File: *Kingston HIF Wastewater Scheme*  
Your Ref: *RM20.164.01*

### **RFI RESPONSE – CONSENT APPLICATION RM20.164.01: DISCHARGE PERMIT - LAND**

Please find our response to the request for further information for Consent Application RM20.164.01. This cover letter summarises Otago Regional Council queries and the applicant's responses with further detail provided in the accompanying memorandum from LEI with attachments.

Figure 1. Typical Lucerne Growth Pattern

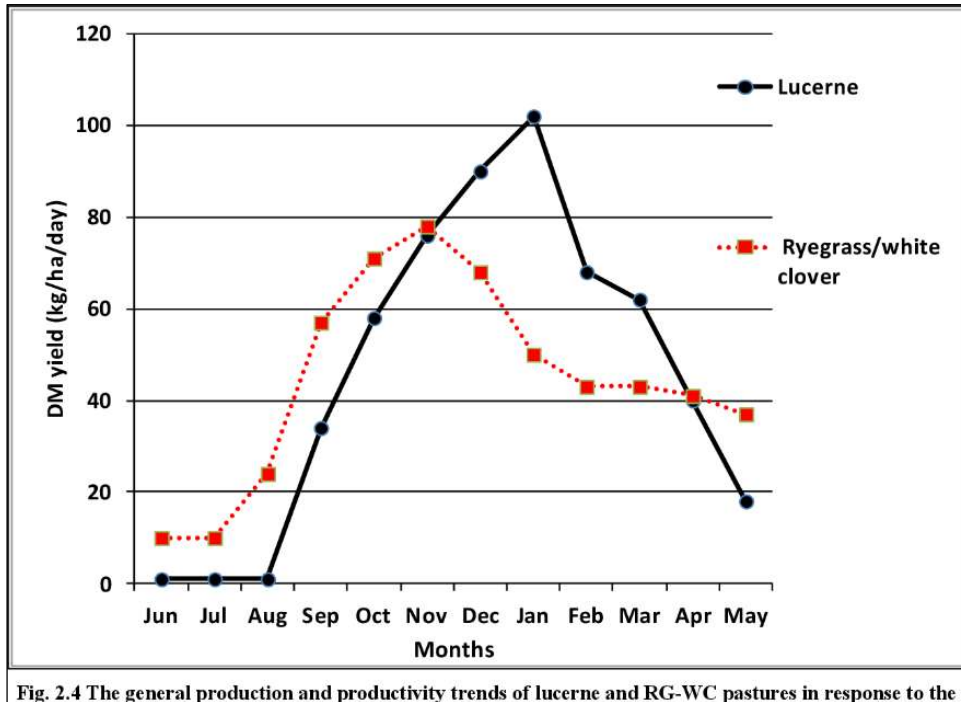
**1) An assessment on nitrogen application, uptake and leaching values on a monthly basis is required to address the effects of nitrogen applied to the LTAs during periods where there is low or no crop growth. The assessment must include (but not limited to):**

- *Potential dry matter production in each month;*
- *Potential nitrogen uptake in each month;*
- *Nitrogen applied in each month, including seasonal variations in effluent quality;*
- *Nitrogen surplus or deficit relative to potential plant uptake;*
- *Nitrogen uptake based on available nitrogen and potential plant uptake;*
- *Nitrogen leaching based on available nitrogen and potential plant uptake; and,*
- *Methods to manage nitrogen leaching during low growth periods or wet periods.*

The parameters used to assess the nitrogen leaching are a combination of direct inputs to the OVERSEER modelling and inherent in the modelling code. Figures 1 and 2 below present typical plant growth rates and the OVERSEER model summaries of the parameters used, respectively.

LEI does not use a separate spreadsheet model to predict monthly nutrient leaching as it has confidence that OVERSEER can be accurately used for this. LEI's experience is supported by the Environment Court accepting the use of OVERSEER for predicted nutrient leaching rates for land application of wastewater.
